# UNITED STATES PATENT AND TRADEMARK OFFICE

| APPLICATION NO.  | FILING DATE | FIRST NAMED INVENTOR | ATTORNEY DOCKET NO.       | CONFIRMATION NO. |
|--|-------------|----------------------|---------------------------|------------------|
| 10/517,735   | 08/08/2005  | Ian Richard Webb     | R&G C-388                 | 5929             |

**Office Action Summary**

## **DETAILED ACTION**

(Straub Figures 1-5)

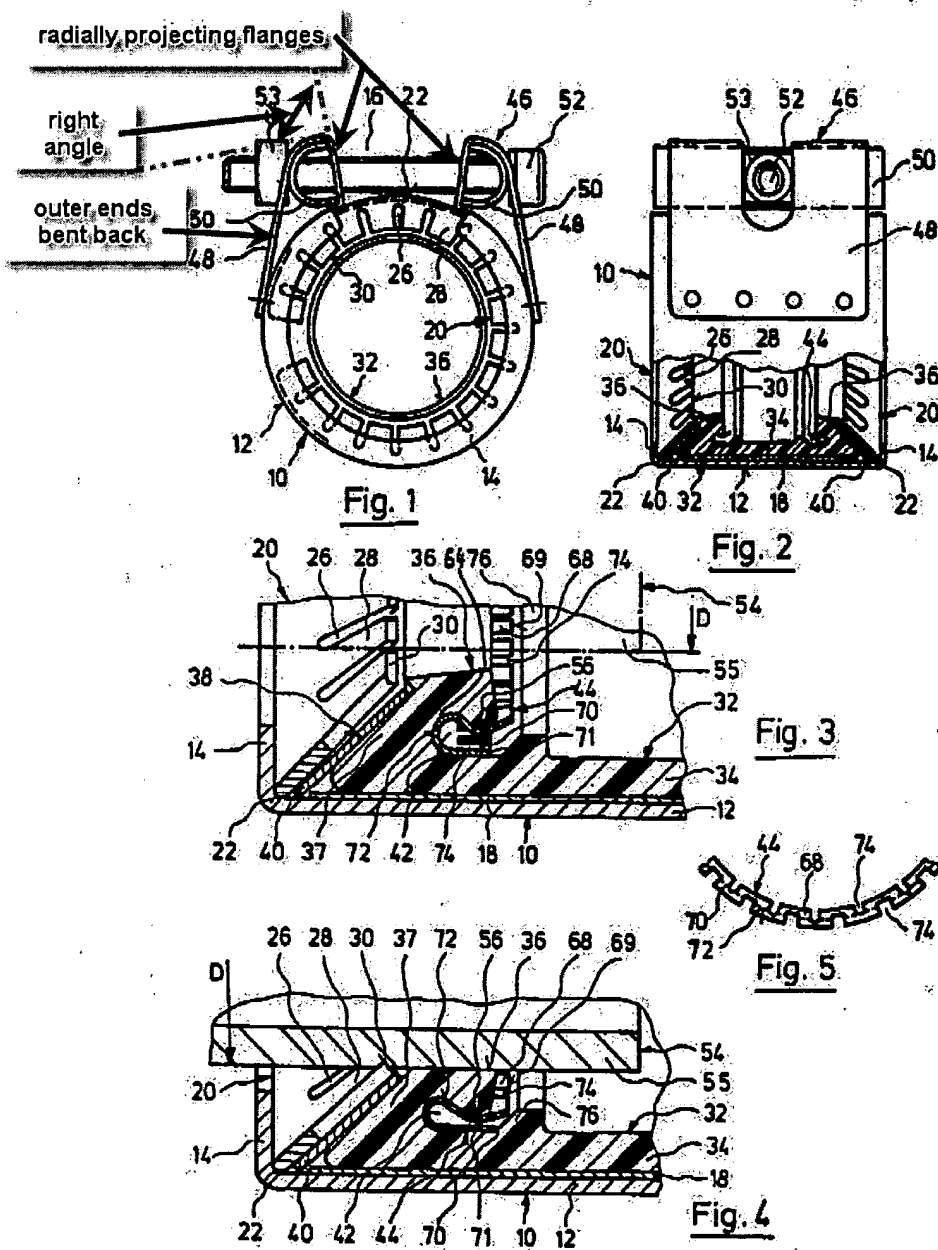
18. In regard to claim 10, Straub, in Figures 1-5, below, discloses a pipe coupling for connecting together the ends of two pipes, comprising:

a tubular casing (10) having circumferentially extending end flanges (14) projecting inwardly from the axial ends of the casing,

a tubular sealing sleeve (32) inside the casing;

tensioning (52 and 53) means for tightening the casing around the sealing sleeve; and

frusto-conical gripping rings (44) located within the casing at opposite ends of the casing, the inner edges of the gripping rings being formed with teeth (68);

the casing comprising a strip of metal formed into a tube with a gap (as observed in Figure 1) extending longitudinally of the casing between the free ends of the strip;

20. In regard to claim 16, Straub further discloses that the aligned holes are elongated in the radial direction (as observed in Figure 2).
21. In regard to claim 17, Straub further discloses a backing ring (40 in Figure 3, above) is provided inside the casing adjacent each gripping ring (44) between the gripping ring and the sealing sleeve (32) to prevent the sealing sleeve bulging between the teeth of the gripping ring.

(Straub Figure 1 cutout)

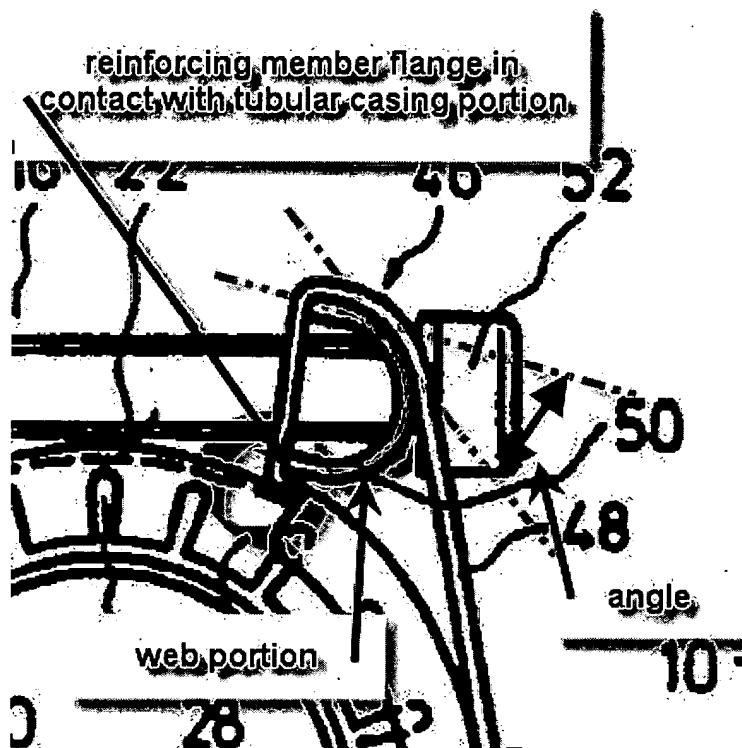
holes in the reinforcing members and the radially projecting flanges, the reinforcing members each having an angled cross-section (the reinforcing members are U-shaped [column 3, lines 8-9] and, therefore, there is an angle formed by the junction of the straight sides and the curved portion as shown in Figure 1 cutout, below) of the , a web portion (shaded in Figure 1 cutout, below) through which the holes for the tensioning means pass, and a flange running along the longitudinal edge of the web portion that is nearer to the axis of the coupling, the flange of the reinforcing member bearing against the tubular portion of the casing.

19. In regard to claim 11, Straub further discloses that each reinforcing member has a channel-shaped cross section with flanges (the straight sides of the U-shape) running along both longitudinal edges of the web portion (as observed in Figure 1 cutout, above).

22. In regard to claim 19, Straub further discloses that the outer ends of the radially projecting flanges are bent back to form stiffening flanges (as observed in Figure 1, above) along the longitudinal outer edges of the radially projecting flanges.

23. In regard to claim 20, Straub further discloses that the radially projecting flanges are bent back at right angles (as observed in Figure 1, above).
